Access Compliance Report Public Rights-of-Way (Curb Ramps)

Intersection ID: 29551Main Street:WHITEHALL_PARK_DRCross Street:ARCO_CORPORATE_DRLocation:SEADA ID: 9F9976363698Ramp Type:PerpDiagInitial Pass/Fail:FailOverall Compliance:NoSeverity Score:21.25

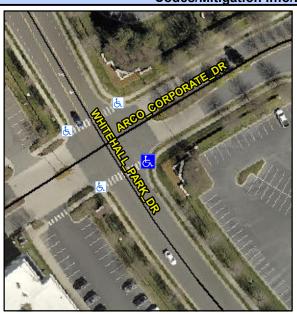
PROW/ADA:
R304.5.1, R304.2.2

Field Measurements/Component Compilance					
Compliance Description		Data	Compliance Description		Data
N/A	Ramp Length (in)	48.0	No	Ramp Slope (%)	10.6
No	Ramp Width (in)	38.0	Yes	Ramp XSlope (%)	0.2
N/A	Flare Type LT	N/A	N/A	Flare Type RT	N/A
N/A	Flare Slope LT (%)	N/A	N/A	Flare Slope RT (%)	N/A
N/A	Flare Traversable LT?	N/A	N/A	Flare Traversable RT?	N/A
N/A	Landing Length (in)	N/A	N/A	DWS Provided?	N/A
N/A	Landing Width (in)	N/A	N/A	DWS Contrast?	N/A
N/A	Landing Slope (%)	N/A	N/A	DWS Length (in)	N/A
N/A	Landing X Slope (%)	N/A	N/A	DWS Full Width?	N/A
N/A	Landing Curb? (Y/N)	N/A	N/A	DWS Offset (in)	N/A
N/A	Shared Landing?	N/A			
N/A	Gutter Ponding?	N/A	N/A	Gutter Slope (%)	N/A
N/A	Gutter Lip Ht (in)	N/A	N/A	Gutter X Slope (%)	N/A
N/A	Painted X Walk1?	No	N/A	Painted X Walk2?	Yes
	X Walk 1 Direction	To NW		X Walk 2 Direction	To W
N/A	X Walk 1 Width (in)	N/A	N/A	X Walk 2 Width (in)	94.0
	X Walk 1 Slope (%)	2.7		X Walk 2 Slope (%)	5.4

X Walk 1 X Slope (%)	3.8		X Walk 2 X Slope (%)	0.8
N/A	Ramp inside XWalk1?	N/A	N/A	Ramp inside XWalk2?	Yes
	Road Slope (%)	2.0	N/A	Clear Space?	N/A
	Road X Slope (%)	3.5	N/A	Clear Space to XWalk (in)	N/A
N/A	Any Obstructions?	N/A	N/A	Storm Grate/Utility Hazard?	N/A
	Obstruction Type			Storm Grate/Utility Type	
		N/A			N/A
			Yes	Surface Condition? (G/P)	Good

Remove & Replace Curb Ramp With
Two New Directional Ramps or
Equivalent.
